To: Emily Anderson, Wild Salmon Center

From: Adam Wlostowski, PhD., Lynker

Subject: Comments on Pebble Project Final EIS

Date: August 7, 2020

Figure 1. HCT results from Pebble Project sample 3069-0927-0947, granodiorite, trickle leach, 2.44% sulfide. Image taken from (Maest & Nordstrom, 2017). The first flush period extends from the test initiation through week ten. Data were transcribed from

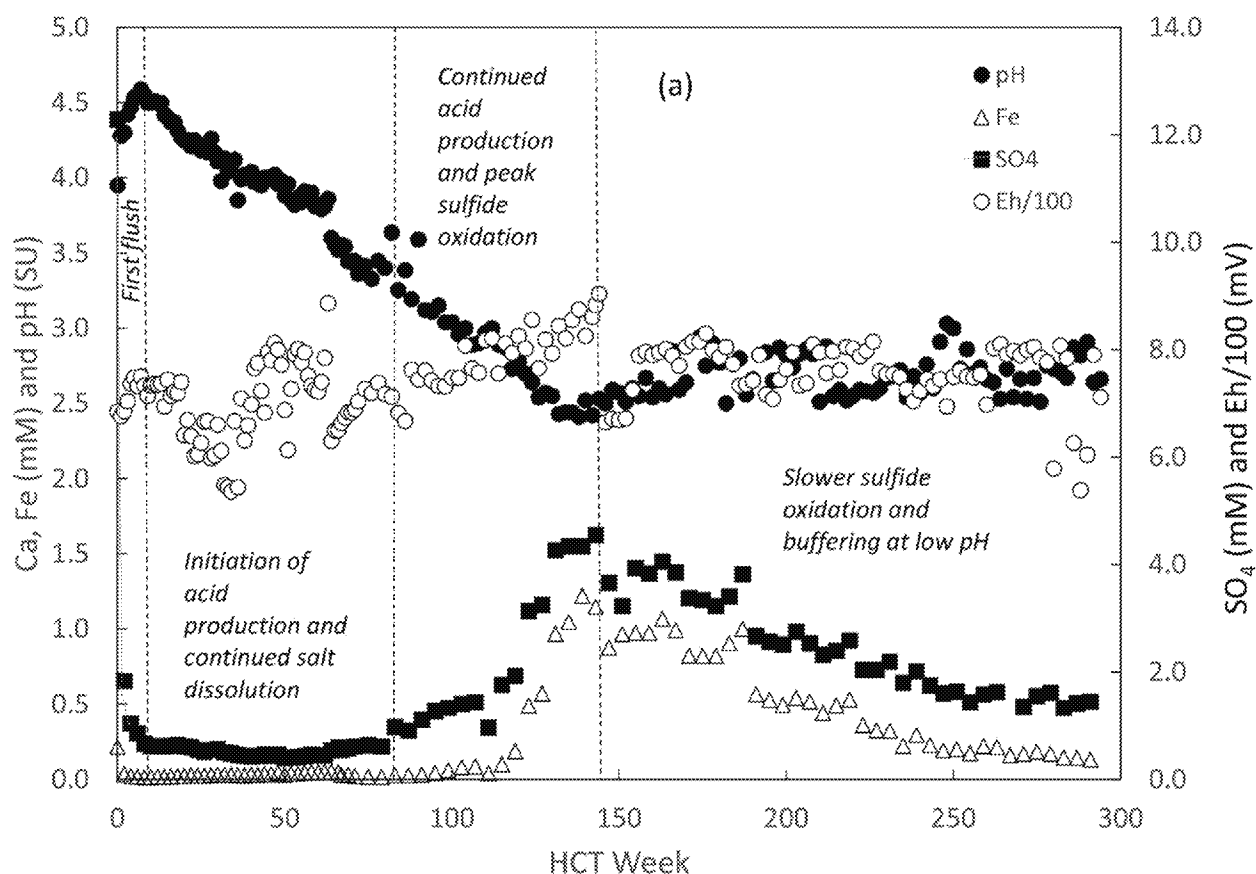
In the context of HCTs on waste rock samples from the Pebble Project, the first flush generally occurs over the first several weeks, when the dissolution of sulfate salts results in elevated concentrations of iron, sulfate, and other constituents (Figure 1). Copper and other metals are also often elevated in first flush releases (PLP, 2018, Appendix 11D-F)

Data shown in Figure 1 were taken from Appendix 11D of the Supplemental Environmental Baseline Data (SEBD) Report (PLP, 2018). Visualizations of HCT test results on Pre-Tertiary waste rock are shown in Appendix 11F of the SEBD. A plot showing sulfate release rate with time is copied directly from Appendix 11F of the SEBD and shown in Figure 2. Results for sample 3069-0927-0947 (red triangles) show an initial peak sulfate release rate of approximately 500 mg/kg/wk. Sulfate release rates drastically decline between test initiation and day 500 before rising again to a secondary peak rate of 206 mg/kg/wk near day 1000. The average sulfate release rate gleaned by PLP for test results for sample 3069-0927-0947 is 43 mg/kg/wk (PLP, 2018, Table 11-12⁵), approximately 12 times lower than the first flush rate and 5 times lower than the secondary peak rate at day 1000.

Averaging over post-flush data ignores useful transient information in HCT results. For example, Figure 1 shows a progressive rise in sulfate and iron concentration, coincident with a steady drop in pH between weeks 75 and 100 for sample 3069-0927-0947 (sulfate data are also presented in Figure 2). As shown by Maest & Nordstrom (2017), this is the time of peak sulfide oxidation and continued acid production. During this time, the maximum sulfate release rate is 206 mg/kg/wk, or five times higher than the post-flush average release rates. By averaging over data following the first-flush, transient spikes in solute release rates are discounted, leading to a low-end estimate of weathering rates. Moreover, as argued by Maest & Nordstrom (2017), it is unreasonable to assume that HCT data are indicative of steady-state field conditions, not least because steady-state field conditions do not occur. Field conditions are intrinsically unsteady.

- Revise the water quality model terms representing the concentration of waste rock and pit wall runoff and infiltration.
- Specifically, revise flow path #78 (and other similar flowpaths) in the site water quality model (Knight Piesold, 2019, Appendix A, Table A.1), to include periodic flushing events.
- Use early-time HCT data and barrel test results to quantify the additional solute loading associated with flushing events.

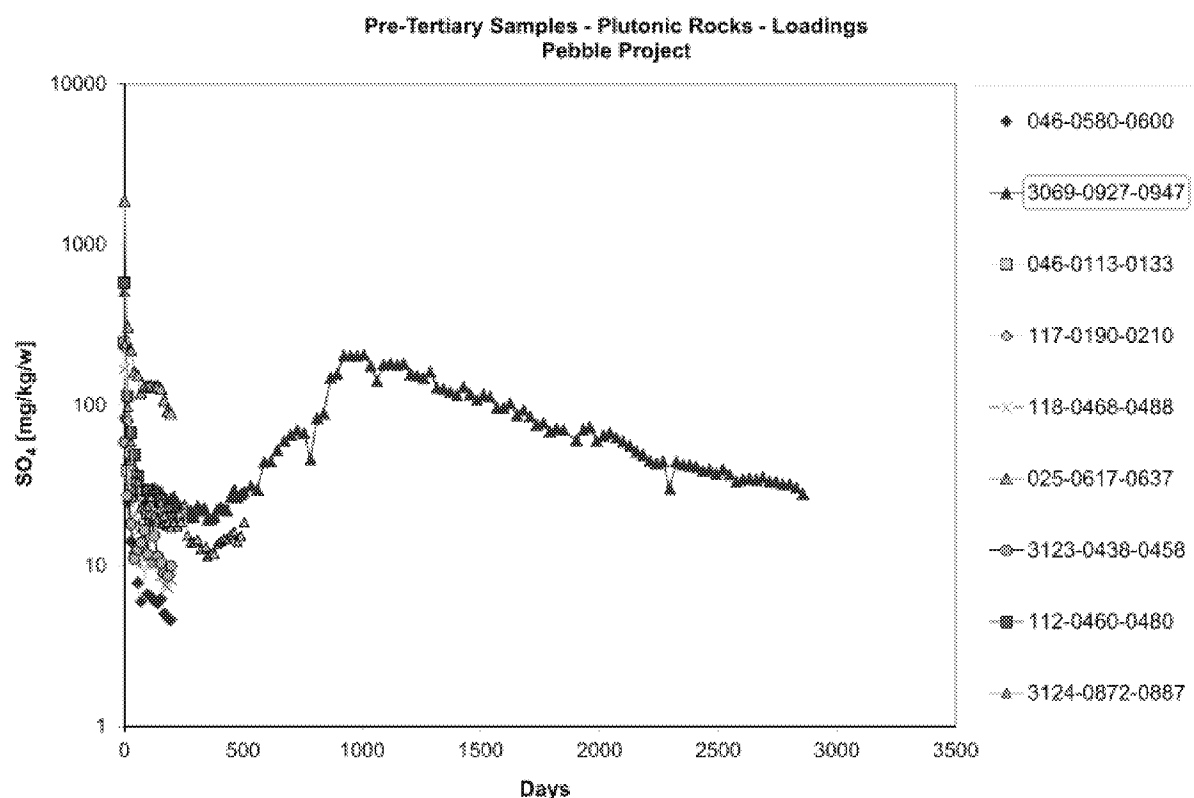
Visually, “stable” data would seem to correspond to HCT data from the very end of an HCT when there is relatively little variability in sulfate release. In the test results shown in Figure 1 and 2, this would likely correspond to data beyond week 200. It is hard to say for sure because neither the DEIS nor the FEIS report the period of each HCT considered “stable.” Regardless, the selected stable times are not representative of salt leaching or peak sulfide oxidation, which both occur earlier in the tests (Maest & Nordstrom, 2017).

Figure 3. Subaqueous column test results show continued acid generation from initially acidic samples. Figure taken from Appendix 11G, Graph 1 of 38 in the Pebble Project Environmental Baseline Data Report.

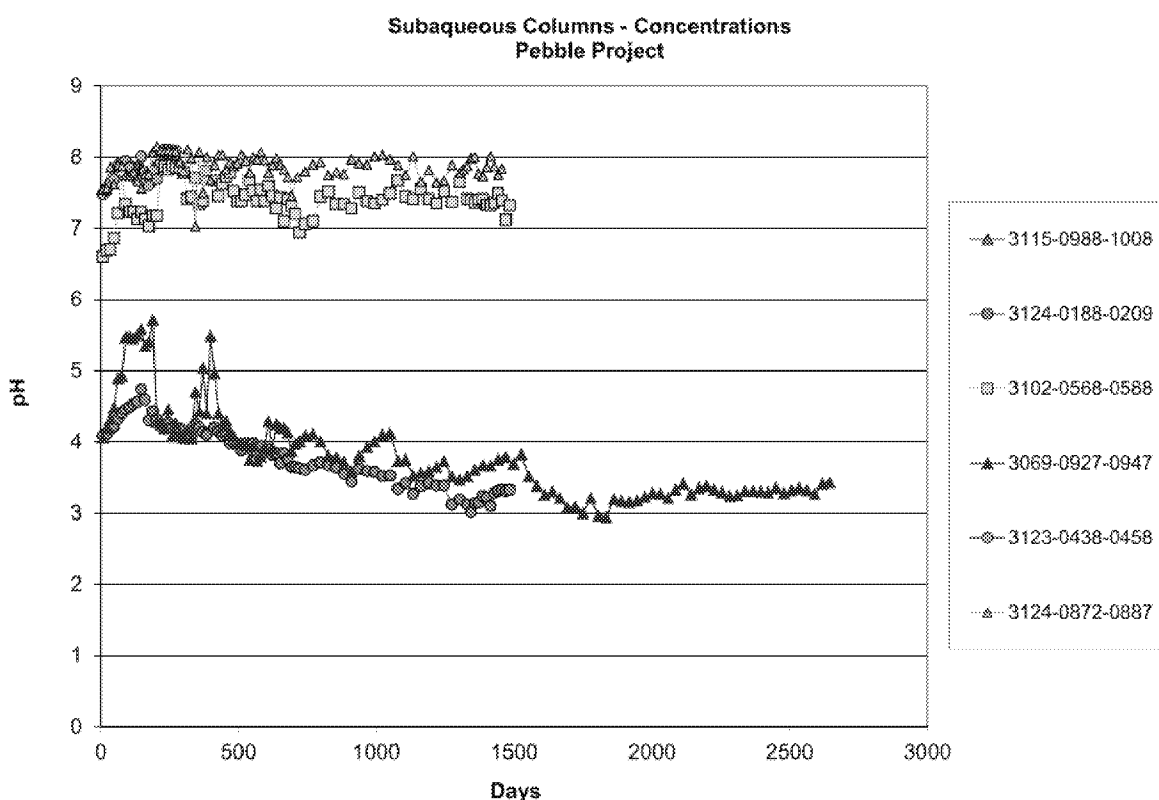
PLP’s own subaqueous column tests highlight the potential for subaqueous leaching (PLP, 2018). Initially acidic samples became even more acidic in subaqueous column tests. These samples also continued to leach copper and arsenic (PLP 2018, Appendix 11, samples #s 3124-1088-0209 & 3069-0927-0947). The results of PLP’s tests clearly show that waste rock can continue to generate acid and leach metals if it is already acidic when submerged (Figure 3). Subaqueous acid generation and metal leaching is corroborated by Lapakko et al. (2013) who observed a gradual decline in pH and increasing copper

concentrations over four years in subaqueous column tests on unmitigated waste rock samples.

- Recalculate source terms for submerged PAG materials (tailings materials and PAG waste rock) in the PTSF during operations and the open pit during closure to acknowledge the potential for the continued leaching shown in geochemical tests.
- Specifically, consider the potential for ferric iron and nitrate driven oxidation of pyritic wastes.
- Investigate the mixing environment of the PTSF and pit to quantify the likelihood of dissolved oxygen interacting with submerged wastes.
- Consider treating waste rock and tailings with lime or other alkaline additions to reduce acid generating potential.

Figure 4. Humidity Cell Test results for Pebble West Zone Tertiary samples show that pH continuously decline for two samples analyzed beyond 2000 days. The graph was taken from the Supplemental Environmental Baseline Data Report, Appendix 11E.

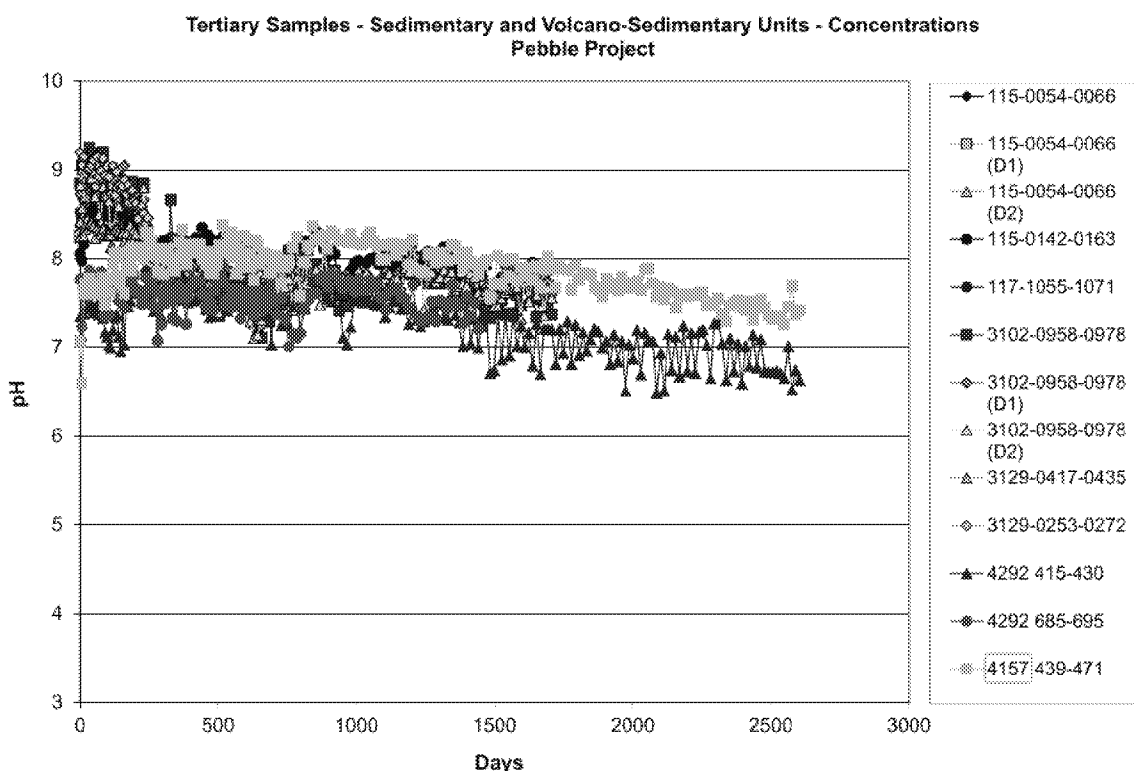
PLP’s own geochemical tests shows that non-PAG (Tertiary) waste rock leaches metals, sulfate, and other mine-related contaminants. Shake flask test results of Tertiary waste rock presented in the

Environmental Baseline Data Report, Figure 11-42, show elevated concentrations of selenium and arsenic. Humidity cell testing of Tertiary waste rock shows that it has the potential to generate acid and leach contaminants over long periods of time. HCTs for two Tertiary waste rock samples from Pebble West zone were continued for more than 2500 days, longer than any other Tertiary waste rock samples (Supplemental Environmental Baseline Data Report, Appendix 11E Graph 1 of 37, samples 4157-439-471 and 4292-514-430). These samples show a progressive decline in pH from day 1000 onwards (Figure 4). While the pH of the leachate does not drop below 6, the rate of change in pH trends in a concerning direction, especially considering the FEIS site water quality model ignores inputs from Tertiary waste rock.

- Revise Appendix N of the FEIS to include a plan for reliably identifying CL from non-CL waste rock.

Figure 5. Humidity cell test results for Pebble West Zone Tertiary rock show increasing copper leach rates for two samples analyzed beyond 2000 days. The graph was taken from the Supplemental Environmental Baseline Data Report, Appendix 11E.

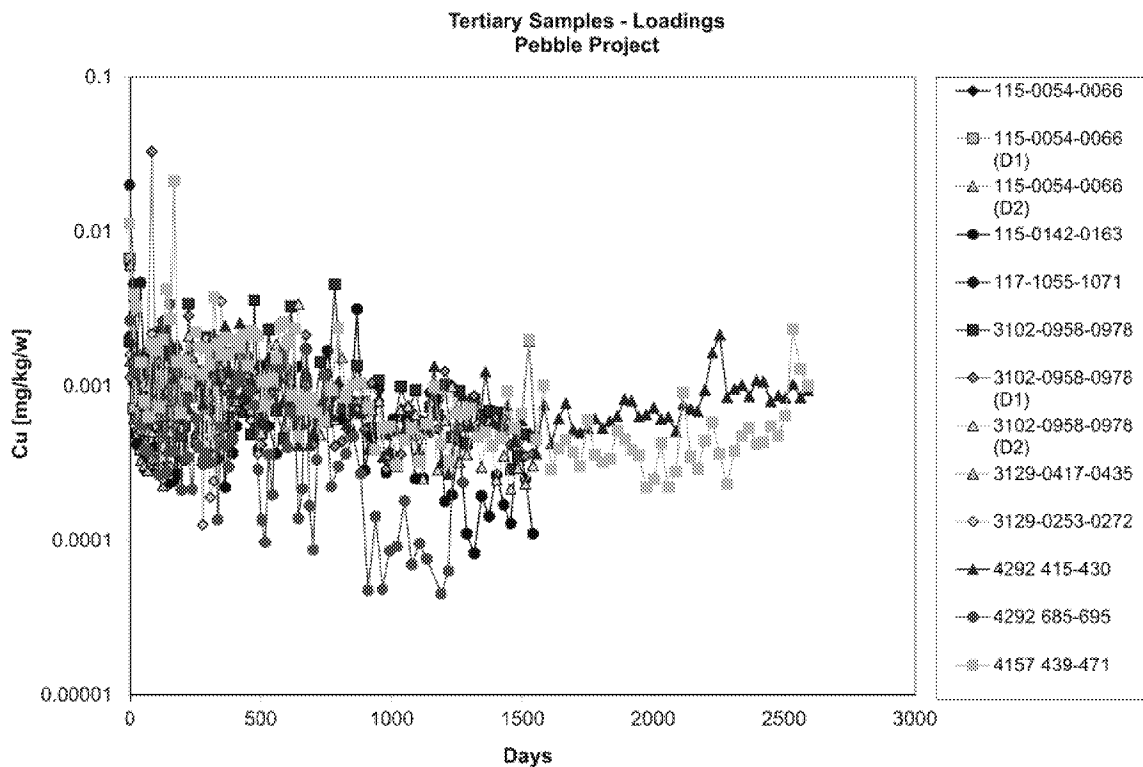
Figure 5 shows the copper leach rates for the Tertiary samples shown in Figure 4. Increasing copper leach rates occurs coincidentally with the drop in pH observed in samples 4157-439-471 and 4292-514-430 (see Figure 5). From day 1500 or 2000 onwards, copper leach rates increased. The rate of change in copper release rates increases with time at the tail end of the test, suggesting that copper leaching from Tertiary waste rock may become progressively more concerning with time.

Figure 6. Humidity Cell Test results for Tertiary waste rock samples from the Pebble East Zone show that pH drops below 6 for three Tertiary samples, indicating that these samples are PAG. The graph was taken from the Supplemental Environmental Baseline Data Report, Appendix 11E.

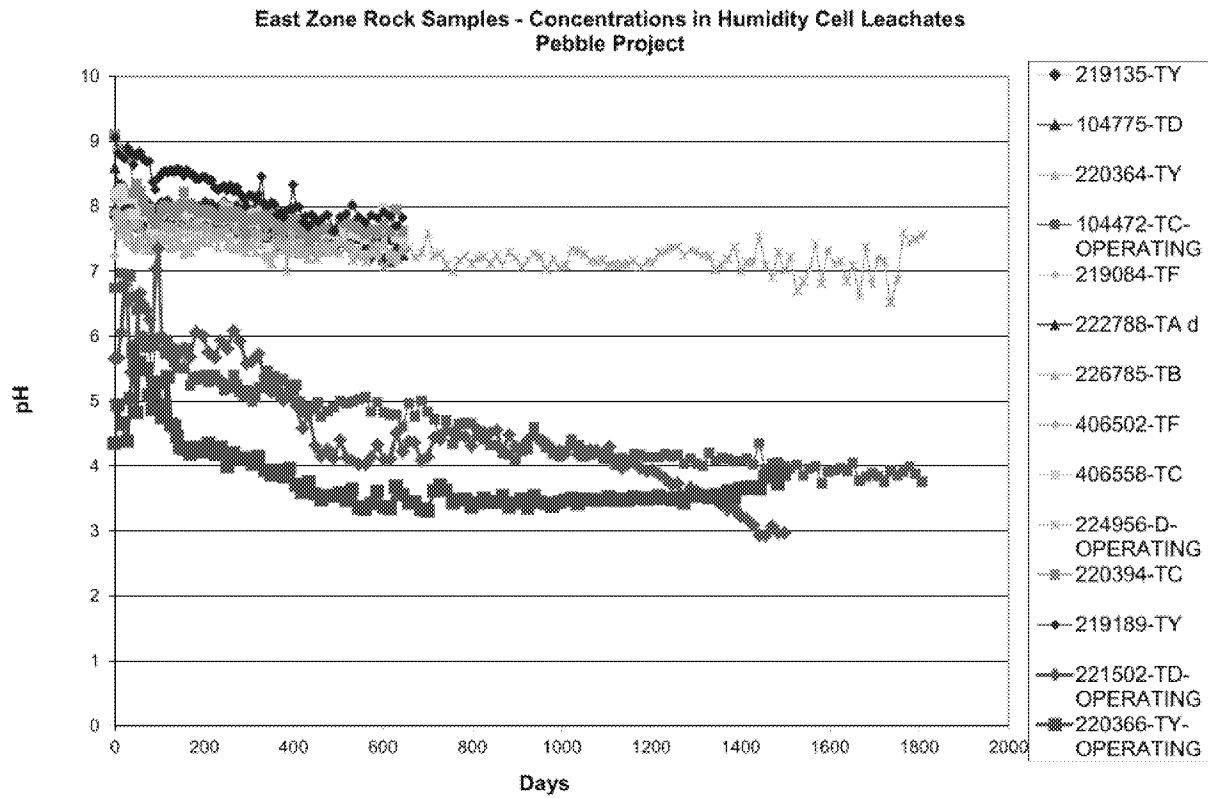
HCT results from Tertiary waste rock samples from the Pebble East Zone are also concerning. Data show that some Tertiary waste rock samples become progressively more acidic with time (Figure 6). Three samples generate leachate with pH values less than 4 at the conclusion of the test. Coincident with the drop in pH for samples 104472-TC-OPERATING, 221502-TD-OPERATING, and 220366-TY-OPERATING, is a rise in metal and metalloid leach rates. For example, copper leach rates for these samples increase logarithmically through time (Figure 7). Although these waste rock samples are geologically classified as Tertiary, which are assumed to be non-PAG, they generated acid and leached contaminants. These results highlight why classifying waste rock by geologic age is an inadequate approach for discerning PAG v. non-PAG and CL vs. non-CL wastes.
